# **MIDUS Transportation Package Pre-Submittal Meeting**

**November 3, 2005  
Rockville, MD**

# Design Changes Since July

# Shielding-Related Changes

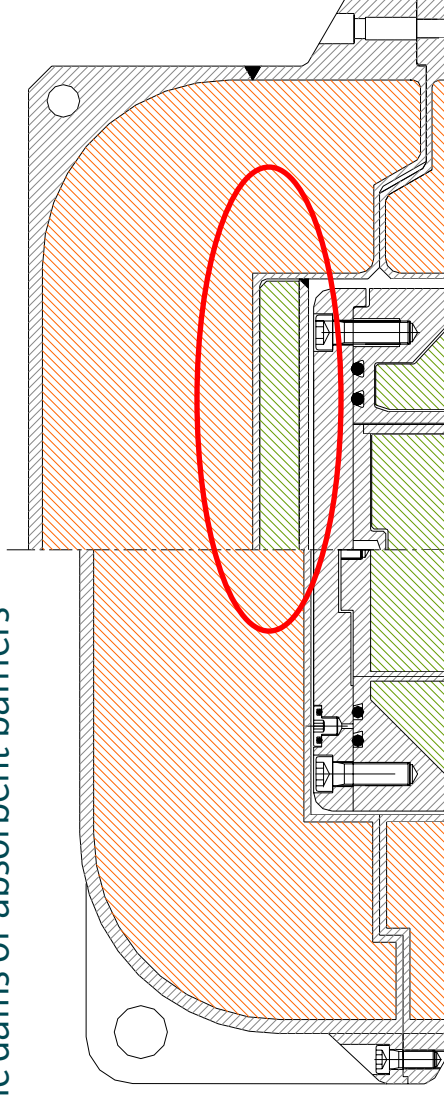
- **NRC Comment from July 21 Meeting (Studsvik Lesson Learned)**
  - Liquid payload could wick up into the shield plug gap- bypassing much of the package shielding.
  - Looked at four options:
    - > Make the cleanliness seal the containment seal (process problem)
    - > Separate containment vessel (process problem)
    - > Precision tolerances (not effective)
    - > Additional DU shielding on overpack lid (added lid weight a problem)
    - > Elastomeric dams or absorbent barriers

## ➤ **Changed to Flush Shield Plug Top Surface.**

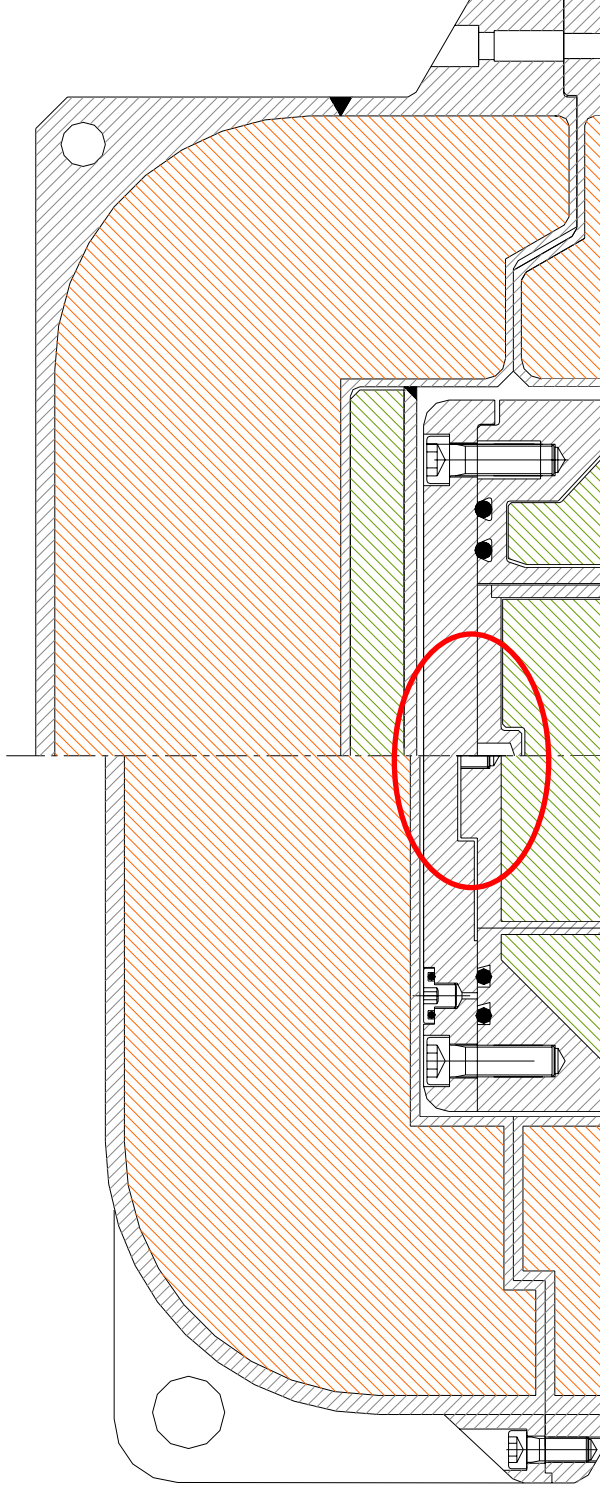
- Removing stepped shield plug top eliminates a major potential “trap” for liquid product to collect.
- Minimizes need for high precision machining.

## ➤ Stepped Lid Modified to Protect Bolts from Shear Loading

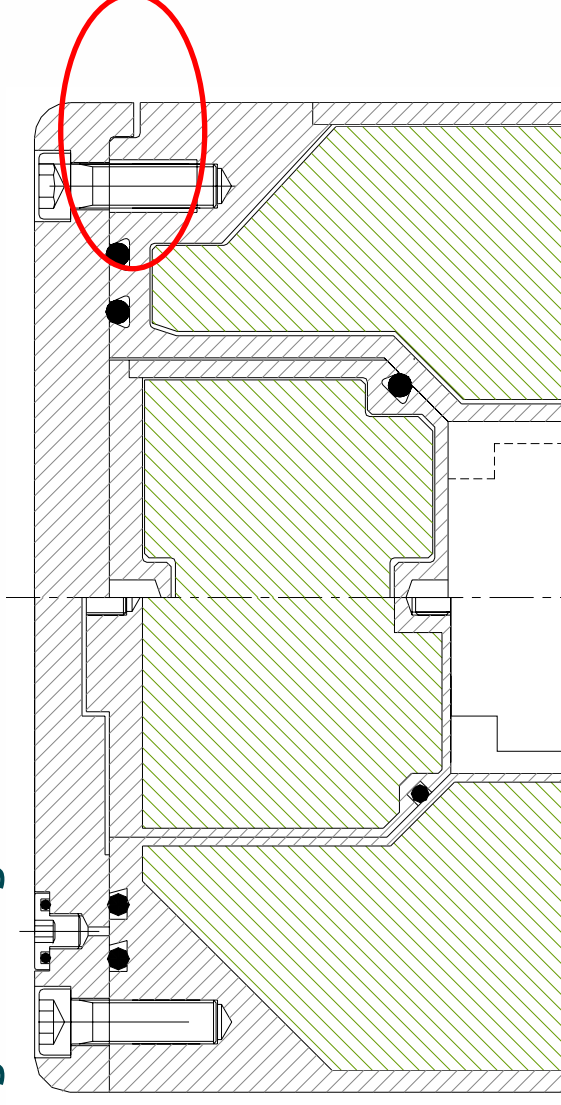
- Preliminary bolt evaluation showed bolt shear stresses due to NCT side drop exceeded allowable stress limits.
- Considered increasing number/size of bolts, adding shear pins, or modifying lid design.

## ➤ Increased Thickness of Containment Shell Near Shield Plug Region.

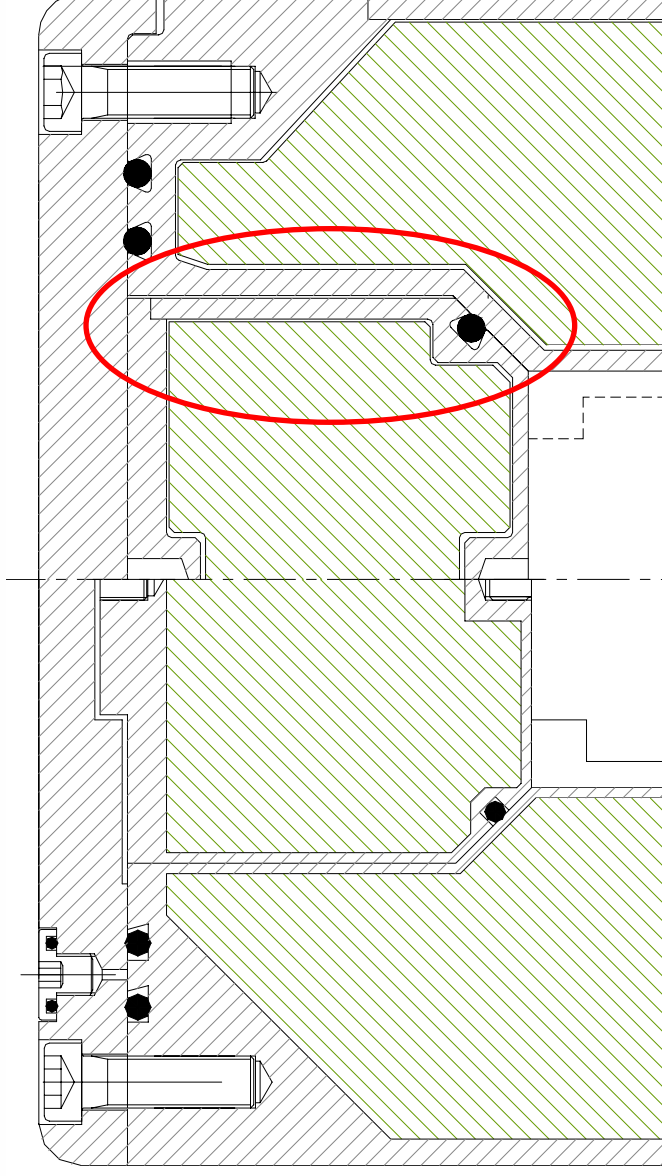
- Stresses due to side drop loads exceeded allowable stresses.
- Containment shell acts as cantilever beam in side drop.

## ➤ Increased Size of Overpack Bolting Flange

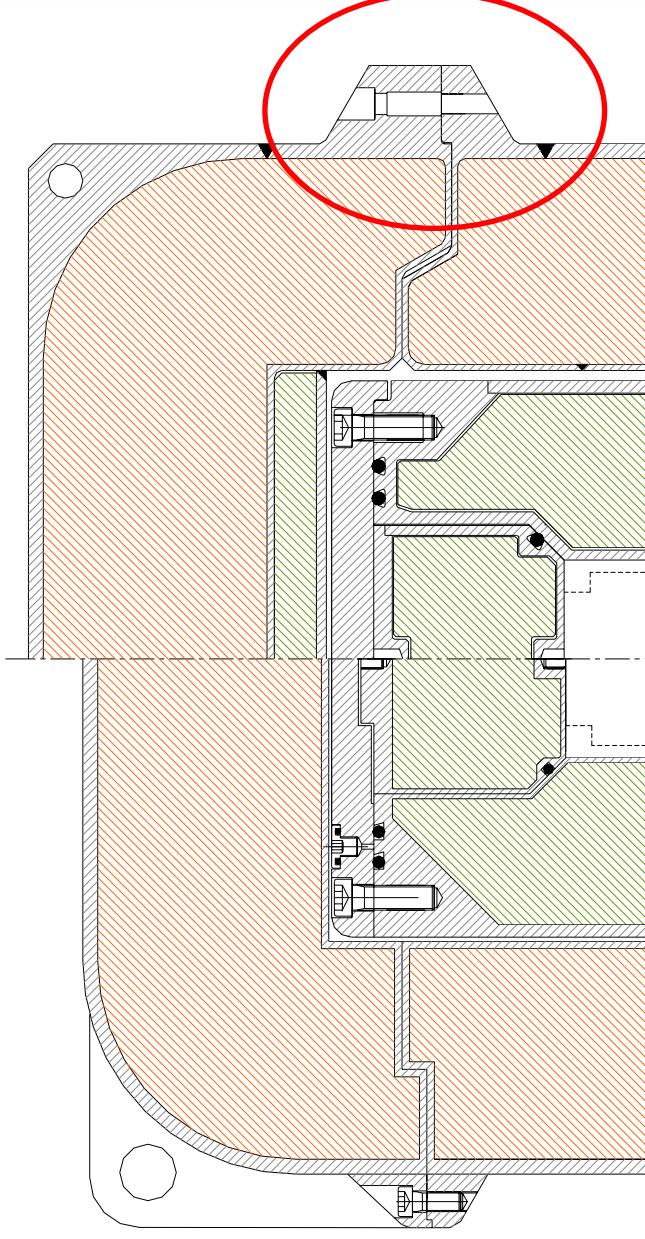
- Increased size of shear lip
- Increased bolt length for added flexibility
- Added bolt shear relief pocket

# Thermal-Related Changes

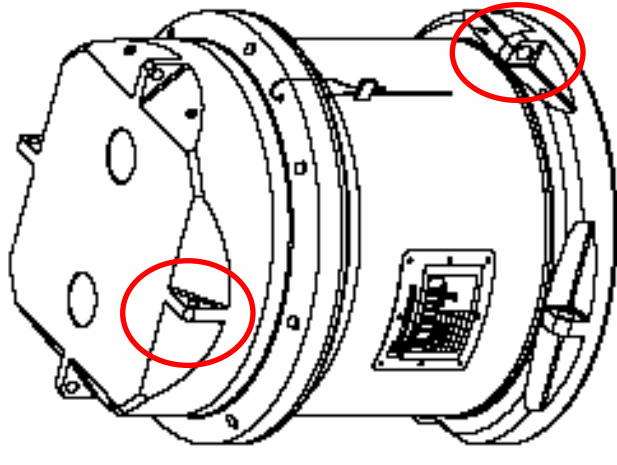
- **Increased Foam Density From 10 to 12 lb/ft<sup>3</sup>**
  - Initial thermal review showed that the containment O-ring seal area temperatures might be a problem.
  - Temperatures are a strong function of foam density.
  - 12 lb/ft<sup>3</sup> foam should provide good thermal margin.
- **Added Thermal Test to Confirmatory Test Program.**

## ➤ Side Drop Stress Analysis

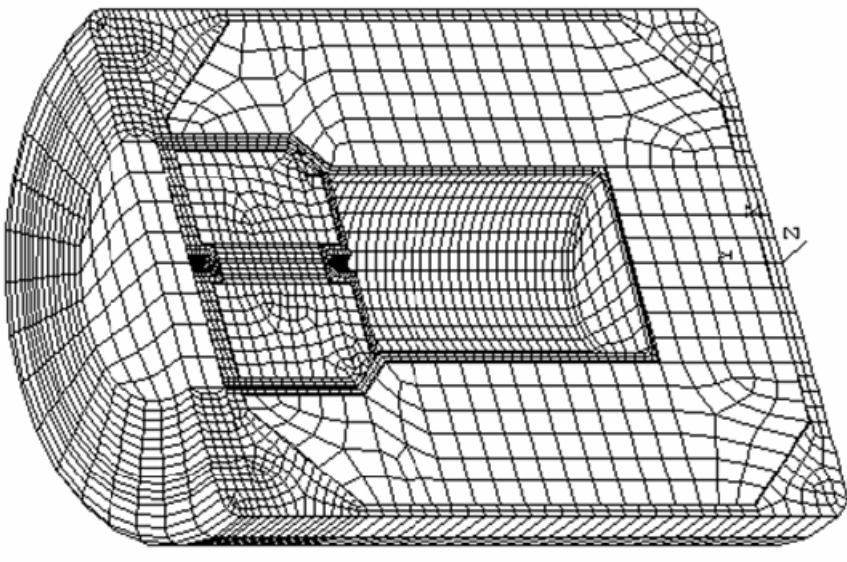
- **Side Drop Stress Analysis (continued)**
  - Preliminary Analysis [Results](#)
    - > Inner containment shell stresses in shield plug region exceed allowable stress limits
    - > Reduce stresses by increasing inner shell thickness in shield plug region
